<b>Title - Sujet</b> Kentville Winery	
<b>Solicitation No. - N° de l'invitation</b> EB144-182595/A	<b>Amendment No. - N° modif.</b> 003
<b>Client Reference No. - N° de référence du client</b> EB144-18-2595	<b>Date</b> 2018-02-27
<b>GETS Reference No. - N° de référence de SEAG</b> PW-\$PWA-121-5719	
<b>File No. - N° de dossier</b> PWA-7-78135 (121)	<b>CCC No./N° CCC - FMS No./N° VME</b>
<b>Solicitation Closes - L'invitation prend fin</b> <b>at - à 02:00 PM</b> <b>on - le 2018-03-01</b>	<b>Time Zone</b> <b>Fuseau horaire</b> Atlantic Standard Time AST
<b>F.O.B. - F.A.B.</b> <b>Plant-Usine:</b> <input type="checkbox"/> <b>Destination:</b> <input checked="" type="checkbox"/> <b>Other-Autre:</b> <input type="checkbox"/>	
<b>Address Enquiries to: - Adresser toutes questions à:</b> Russell (PWA), Alex	<b>Buyer Id - Id de l'acheteur</b> pwa121
<b>Telephone No. - N° de téléphone</b> (902) 401-8180 ( )	<b>FAX No. - N° de FAX</b> (902) 496-5016

**Amendment 003 is raised for the following:**

### SCHEMATIC – PROPOSED PARTIAL SINGLE LINE DIAGRAM

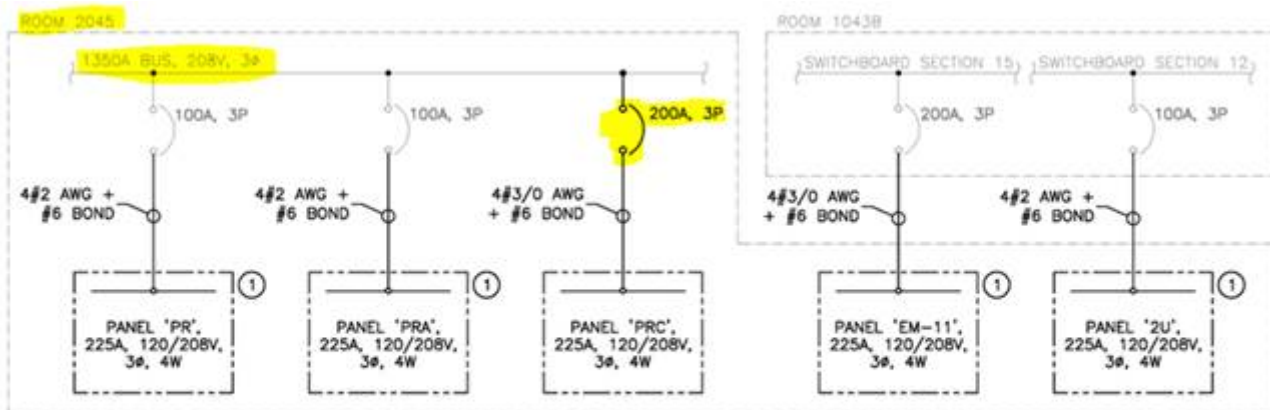
24. Question 14 of addendum # 2 specifies that all panel boards are to be rated 65KIAC . Currently on site most 42 cct panels are 10KAIC. Please confirm that you do indeed want 65KIAC for all panels due to size and cost difference?

25. If our interpretation is wrong and all panels do indeed need to be 65KIAC we are unable to get GFI breakers to fit a 65KIAC panel.

The intent was for all panelboards (120/208V) to be fully rated at 65kAIC as the fault current off of the 1350A bus was calculated to be approximately 45kA. As per new information, we will require 65kAIC series rated panelboards with 10kAIC branch circuit breakers.

Refer to Q24 answer. In order to source GFI breakers, series rated panelboards with 65kAIC main breaker will be accepted in order to meet design requirements. Panels 'PR', 'PRA' and '2U' will each require a main breaker rated 100A, 3P, 65kAIC. Panels 'PRC' and 'EM-11' will require a main breaker rated 200A, 3P, 65kAIC. All series rated panels are to be marked at the time of installation in a conspicuous and legible manner to indicate that components must only be replaced with components of the same type and rating. Contractor is to coordinate series rated panelboards with panelboard manufacturer.

1. ALL PANELS MUST BE FULLY RATED AT 65KAIC AS THE FAULT CURRENT OFF OF THE 1350A BUS WAS CALCULATED TO BE APPROXIMATELY 45KA.
